APPLICATION NO.	FILING DATE	FIRST NAMED INVENTOR	ATTORNEY DOCKET NO.	CONFIRMATION NO.
10/814,478	03/31/2004	Mario Stigler	0275M-911/CO	7889

Office Action Summary

This is the 2nd non-final Office Action for the serial number 10/814,478, RETAINING CLIP WITH OFFSET LATCHING FINGERS, filed on 3/31/04.

See drawing of figure 1 from Wilmes's invention for clarification:

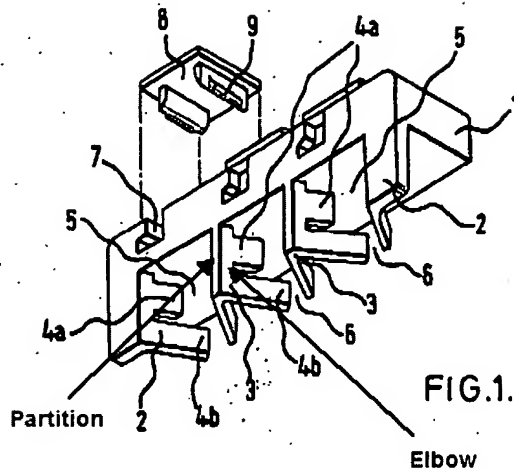
Tomoyoshi teaches the partitions and latching fingers but fails to teach the partitions are elbowed between the latching fingers. Wilmes teaches the partition is elbowed between the offset latching fingers (3 and 4a). It would have been obvious for one of ordinary skill in the art at the time the invention was made to have added elbow to Tomoyoshi's partitions and latching fingers as taught by Wilmes to provide support for the both fingers to remain in an upright configuration when an object is inserted in the receiver which will cause the fingers to move in different direction from each other.
